Airworthiness Directives; Rockwell Collins, Inc. Flight Display System Application

ACTION: Notice of proposed rulemaking (NPRM).

Rockwell Collins, Inc.: Docket No. FAA-2020-0883; Project Identifier 2019-CE-034-AD.

Figure 1 to paragraph (g)(1)(iii); placard location on bezel

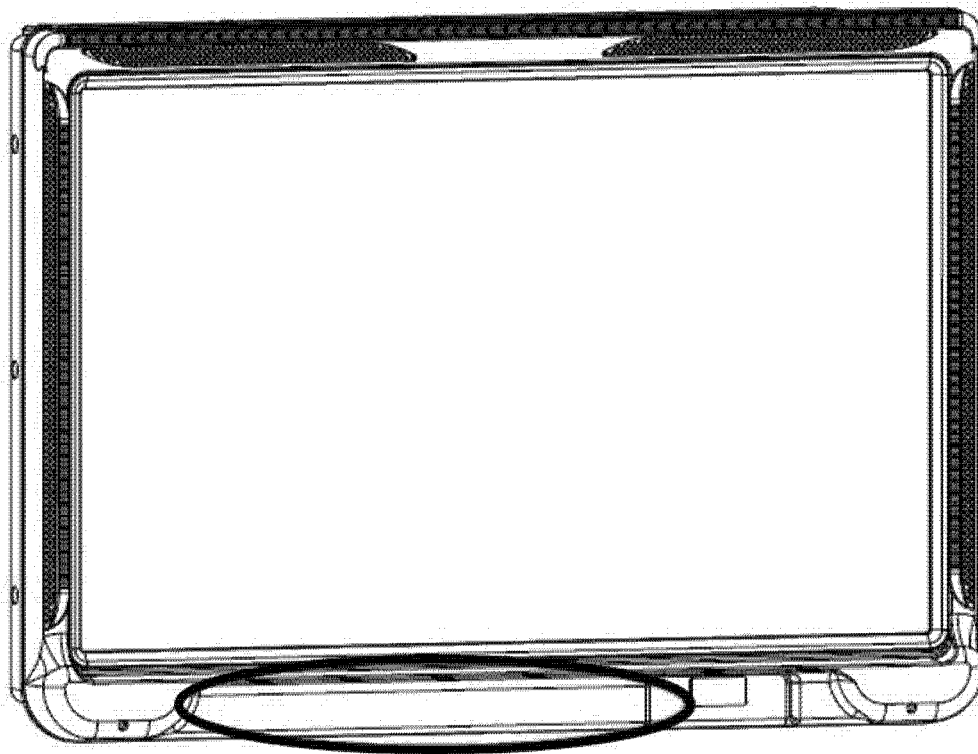
(ii) Fabricate a placard for each aircraft primary flight display, using at least ⅛ inch letters, with the following text: TCAS Flight Ops—TA Only mode (TA/RA mode prohibited).

(iii) Install the placard on the bottom of each aircraft primary flight display bezel in the area depicted in figure 1 to paragraph (g)(1)(iii) of this AD.

(4) The airplane flight manual revision and placards required by paragraph (g)(1) of this AD may be removed after completing the software upgrade required by paragraph (g)(3) of this AD.
